DOE ORDER # 4700.1
94 RF 07388

RECOMMENDATIONS FOR SUPPLEMENTAL SAMPLING IN OPERABLE UNIT 13 - MFM-018-94

CDH Comments to OU 13 Technical Memorandum

FIGURE 3

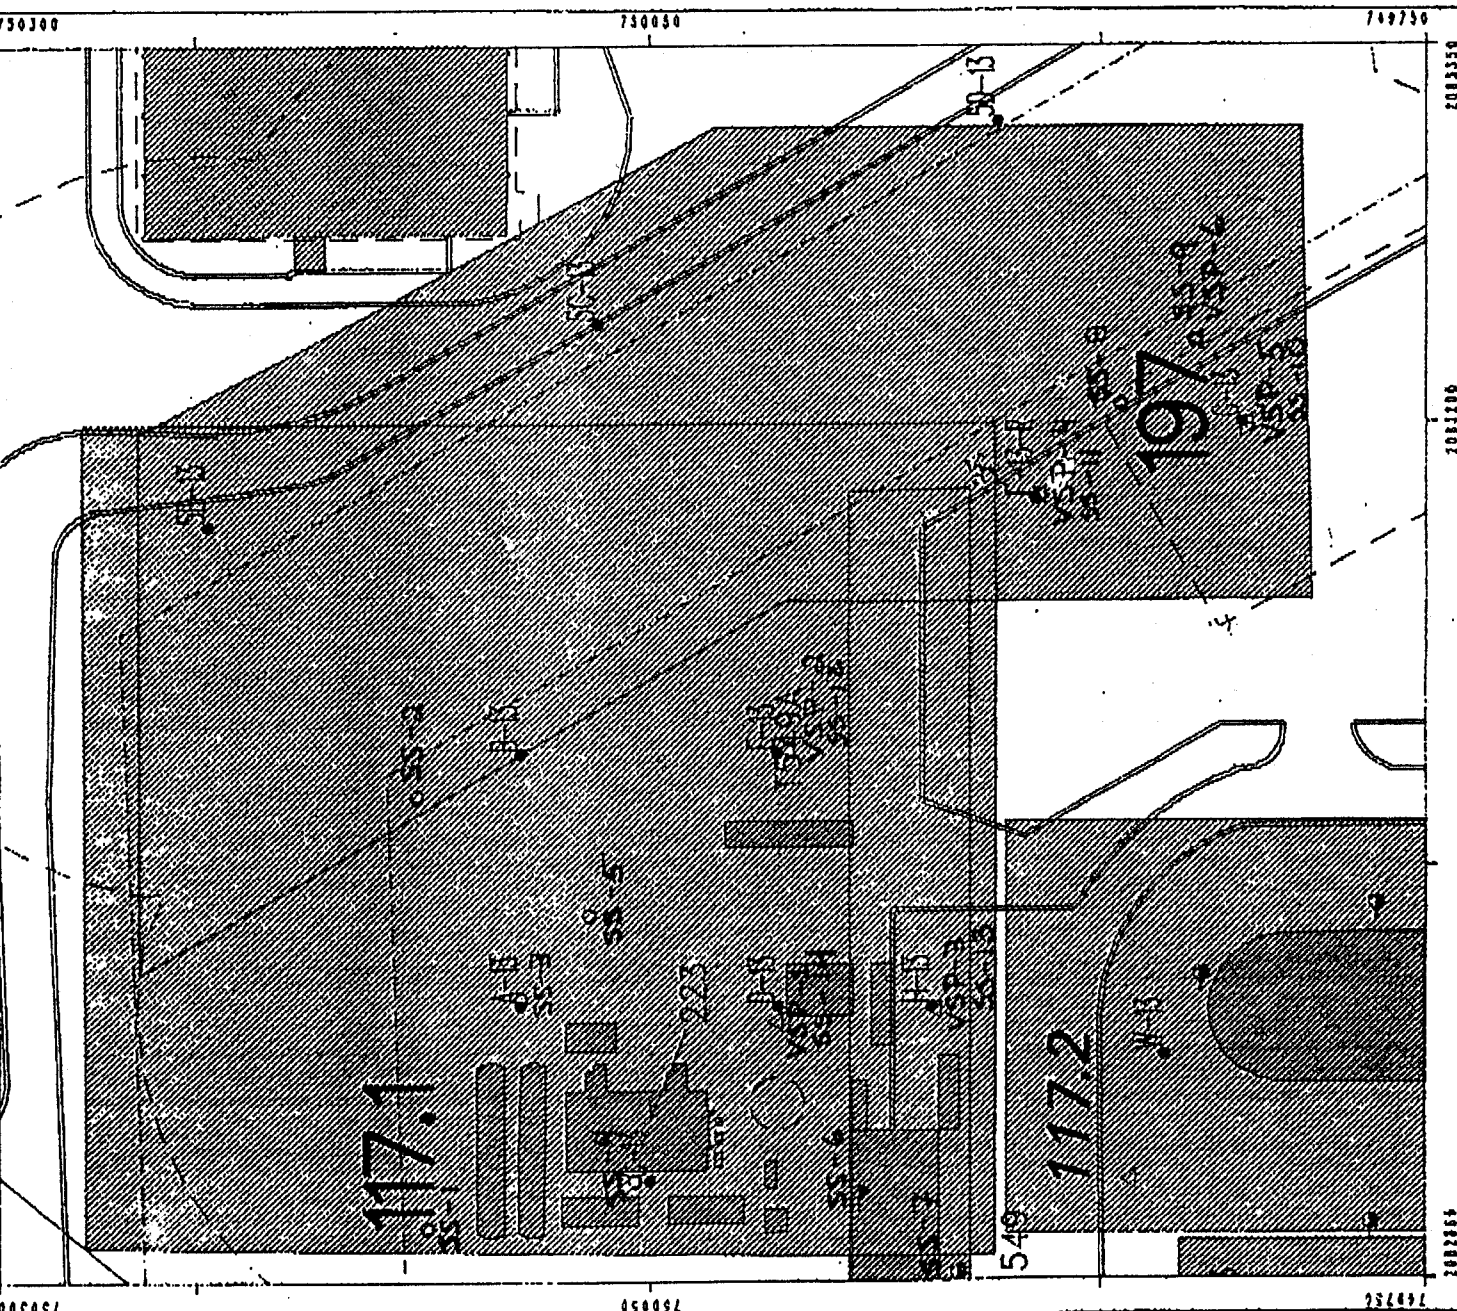
I recommend that we perform this analysis, as requested, based on the results of the waste crate sampling. The analysis will cost approximately \$300 per sample. No more than 20 samples will be analyzed; 14 samples plus Quality Assurance/Quality Control samples as required, at an approximate cost of \$6,000. The cost of the samples is negligible when compared with the overall Stage I Laboratory Analysis costs and can be covered within the current OU 13 budget for this fiscal year without impacting existing work plan activities. By including these analysis, in this round of sampling, we will get a jump on analysis that will be required in Stage II sampling and gain more information about the nature and extent of contamination in Individual Hazardous Substance Sites 117.1 and 197. If you agree, the map of the sampling locations will be faxed to Jeff Swanson.

J.S.	What is the date of the current "spirit" document?	
M.M.	We will provide CDH with a list of document versions.	
T.J.D.	Has the issue of locating asphalt samples in conjunction with HPGe surveys been sufficiently addressed?	
J.S.	The only anomaly may be in IHSS 197. Make sure the soil samples collected below the asphalt are not elevated and locate some asphalt samples in IHSS 197 as well.	
T.J.D.	The next comment is the general comment regarding statistics.	
J.S.	The intent of the comment was to document that the guidance will be used for comparison of sampling results to background.	
T.J.D.	The next comment is regarding Section 1.1 Purpose <u>Analytical Methods for Asphalt and Concrete</u> .
